Docket Number:	16-BSTD-06
Project Title:	Updates to the 2019 Time Dependent Valuation of Energy
TN #:	212512
Document Title:	SoCalGas Comments: On July 15, 2016 TDV Workshop
Description:	N/A
Filer:	System
Organization:	Marc Esser on behalf of Sue Kristjansson/SoCalGas
Submitter Role:	Applicant Consultant
Submission Date:	7/29/2016 3:30:00 PM
Docketed Date:	7/29/2016

SoCalGas July 15, 2016 Lead Commissioner TDV Workshop Comment Letter

July 15, 2016 TDV Workshop Comment Letter

FIGURE 1: NATURAL GAS PRICE FORECAST COMPARISON

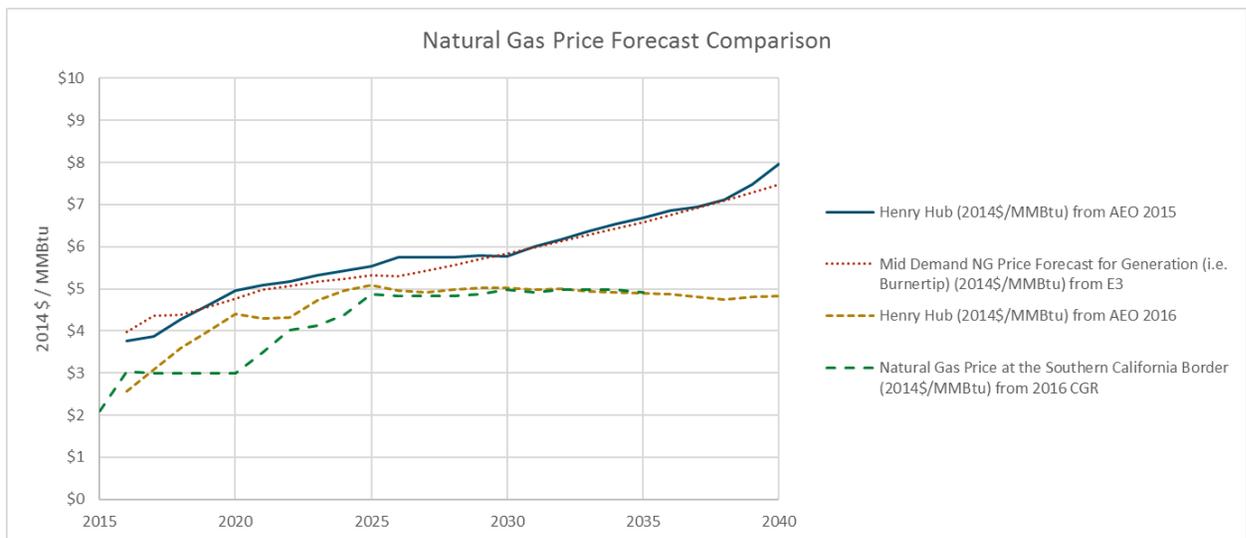
Error! Reference source not found. below depicts four natural gas price forecasts: The Southern California border hub price forecast mentioned above from the 2016 CGR, Henry Hub forecast mentioned above from AEO 2016⁶, the Henry Hub forecast from AEO 2015⁷, and the burner tip price forecast in the TDV model. The graph shows that the burner tip price in the TDV model and Henry Hub from AEO 2015 are well correlated. The Excel spreadsheet, "WECC_2015_IEPR_Gas_Burnertip_Forecast.xls", appears to indicate that the Henry Hub forecast was determined in October 2015. While not shown, please note that the retail annual gas price forecast in the TDV model has a similar positive slope through 2050.

The other two newer data series (bottom two dotted lines), Henry Hub from AEO 2016 and the Southern California border price from 2016 CGR, are also correlated, especially beyond 2025. This similarly makes sense since the border price forecast is highly dependent on Henry Hub and these forecasts are from 2016.

These two pairs of data, on the other hand, are significantly different in that their trends begin to diverge starting 2025, but particularly in 2030 through 2040. By 2040, there is more than \$3/MMBtu difference from what is forecasted using 2015 data versus 2016 data. A linear extrapolation beyond 2026 of the 2015 IEPR retail gas forecast is no longer appropriate and unduly disadvantages natural gas projects. Recognizing that the source information inputs for 2016 are from reputable trusted sources which will contribute to the final 2016 IEPR, it is recommended that the TDV model be updated with this newer 2016 input data.

FIGURE 2: 2014 NOAA QCLCD HOURLY VS. CBECC TMY FOR SAN DIEGO INTERNATIONAL AIRPORT

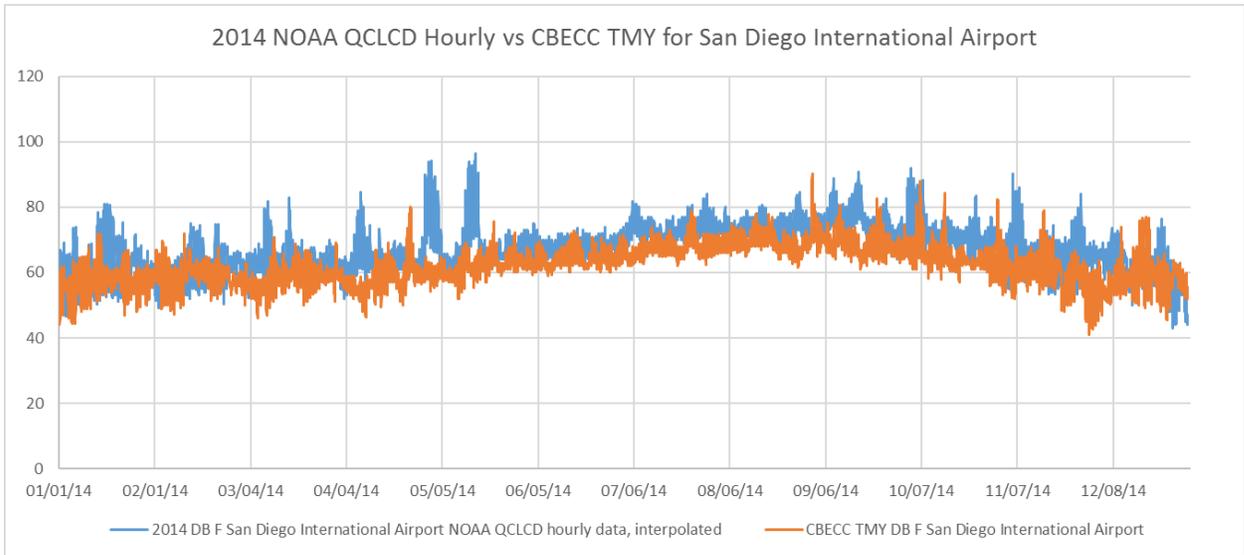
As a spot check of the warming trend, Figure 2 below shows a comparison between 2014 NOAA QCLCD hourly weather data⁹ and the CBECC TMY weather file for the San Diego International Airport. It shows that recent weather (in blue) has been substantially hotter than the TMY data (in orange) for most of the year, even in the winters. Many other locations across California show a similar pattern.

We request the weather files for the 2019 TDV methodology be updated with the most current information available, rather than continue to use the previous files, which by 2020, would be based on data and information outdated by more than 10 years.

FIGURE 3: AVERAGE ANNUAL TEMPERATURES IN CALIFORNIA. NOTE THE SIGNIFICANT INCREASE SINCE 2010 THAT FAR EXCEEDS THE LONG-TERM AVERAGE

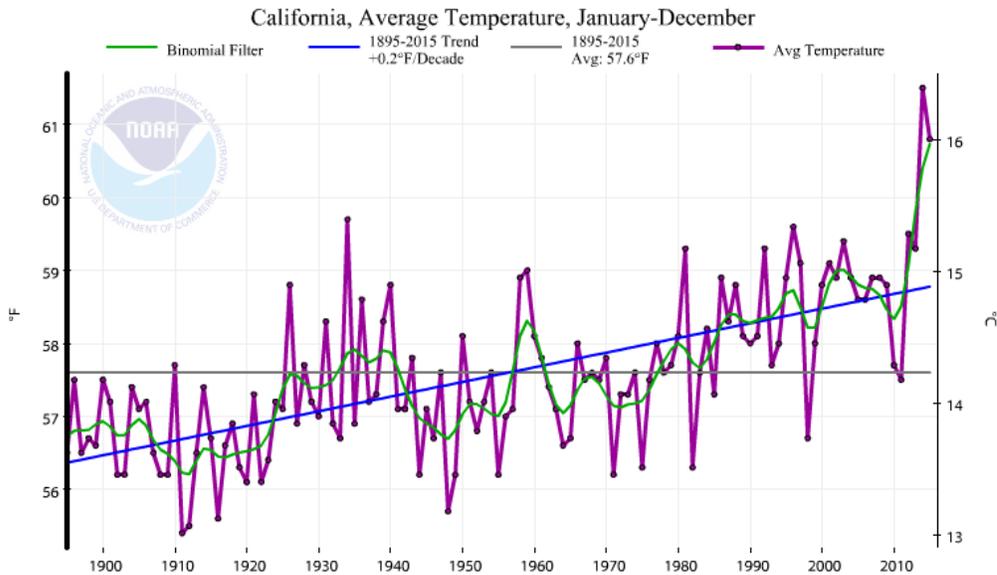
Figure 3 below shows the average annual temperatures in California from 1895 to 2015¹⁰. The average temperature trend shows a steady increase in average annual temperature. In addition to this trend, the average temperatures since 2010 dramatically increased. The creators of the CBECC weather files attempted to account for future weather changes by incorporating future year weather files derived from forecasts, but the large above-average increase in temperature could not have been anticipated.
